Cleveland City Planning Commission

March 20, 2026

Agenda: March 20, 2026

Signage Information

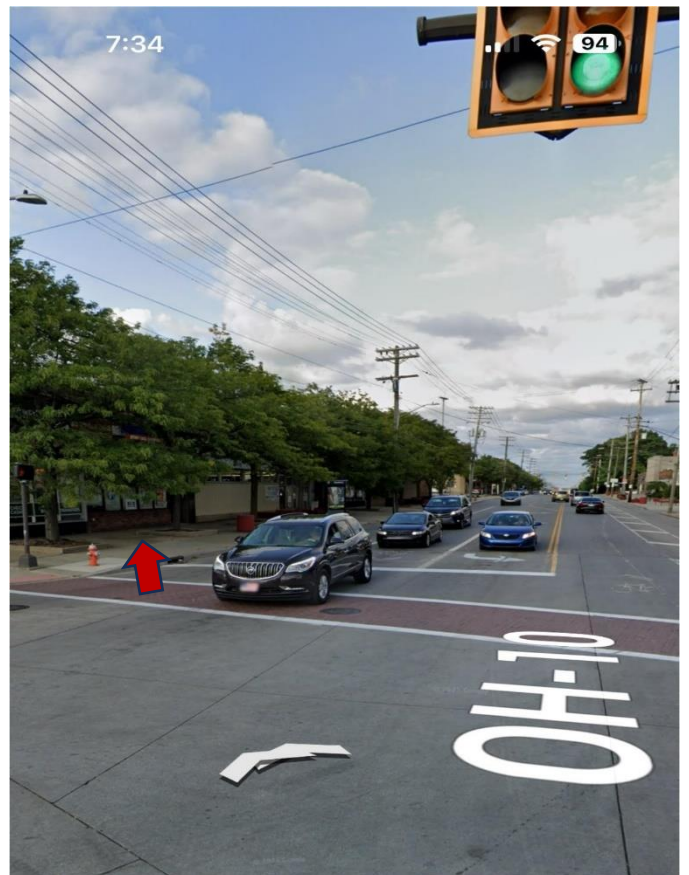
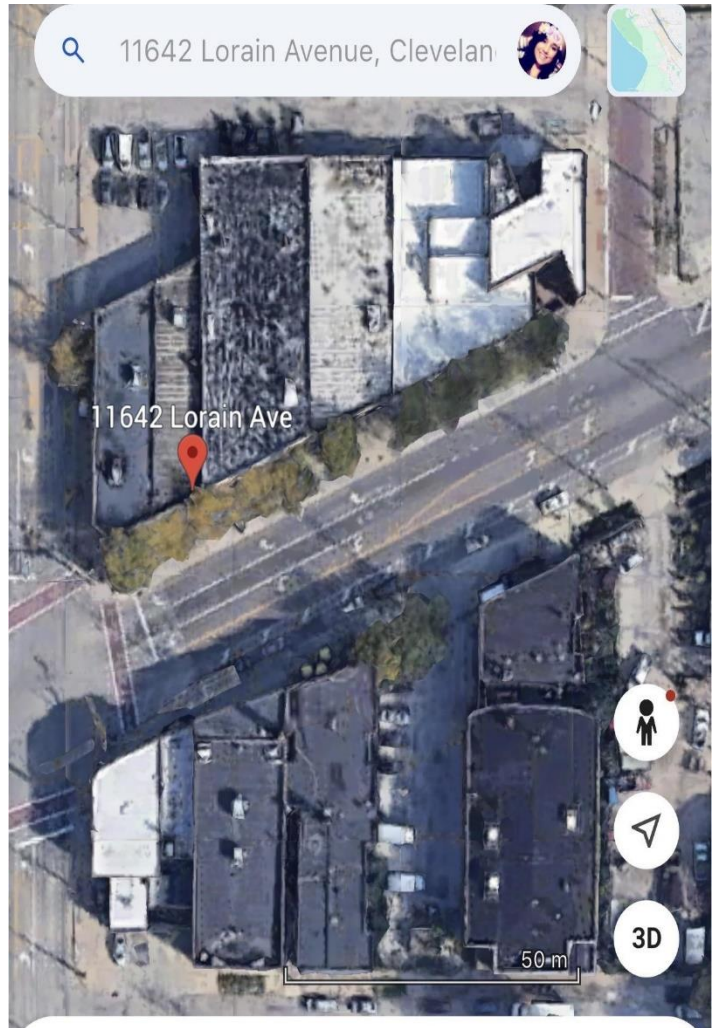
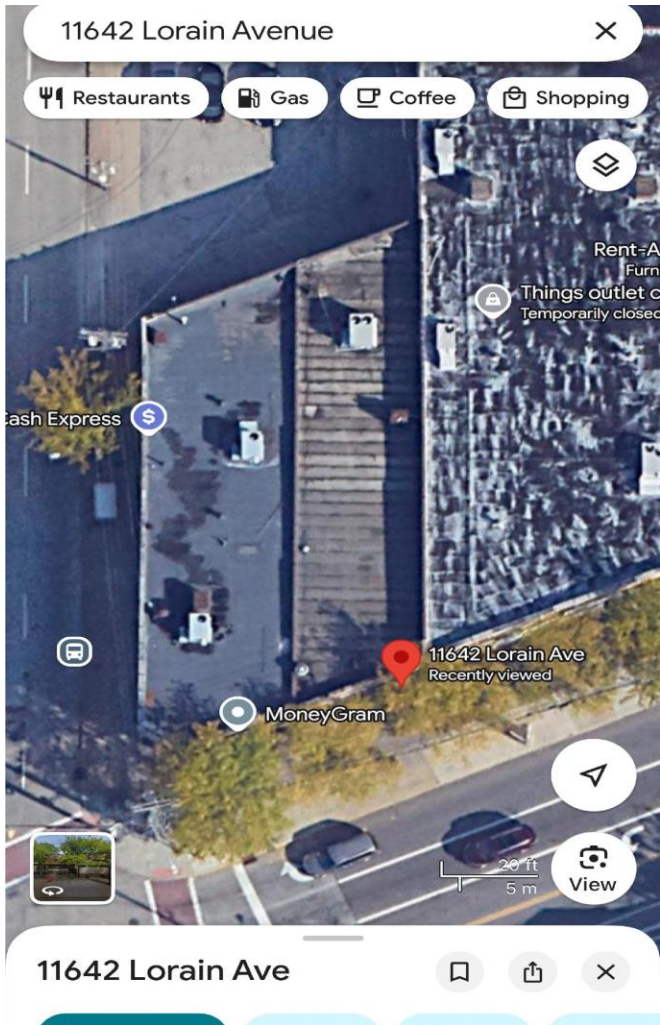
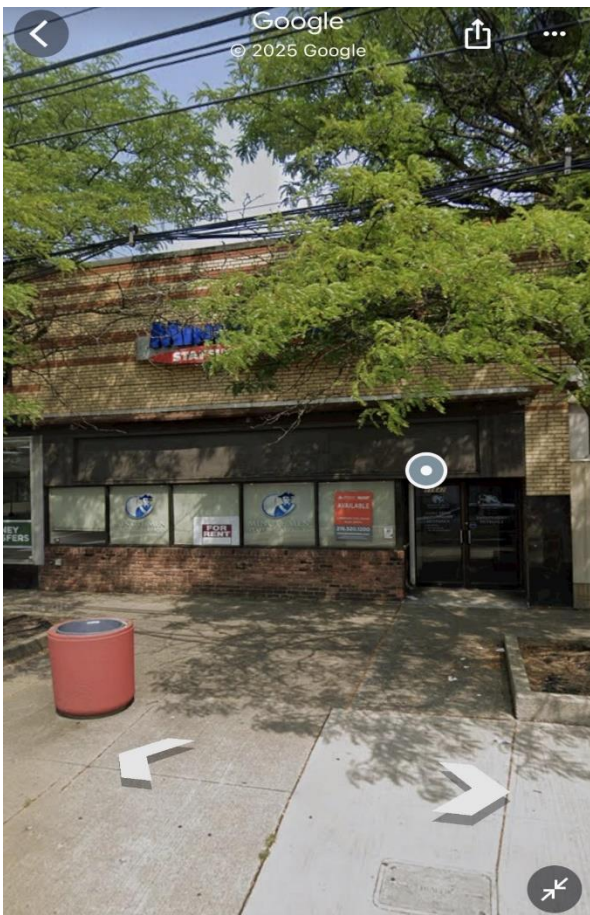
However, we were advised by the committee to not use the vinyl banner on the Front and back of the building with the Daycare name permanently only temporary; and as a permanent sign it should be an Aluminum Composite panel. Which we are working on; and we will not need to use the Vinyl banner

We were also advised to remove one small Vinyl banner that had a few things we offered; and were advised to put it on the door decal instead which I have updated; and that sign has been removed.
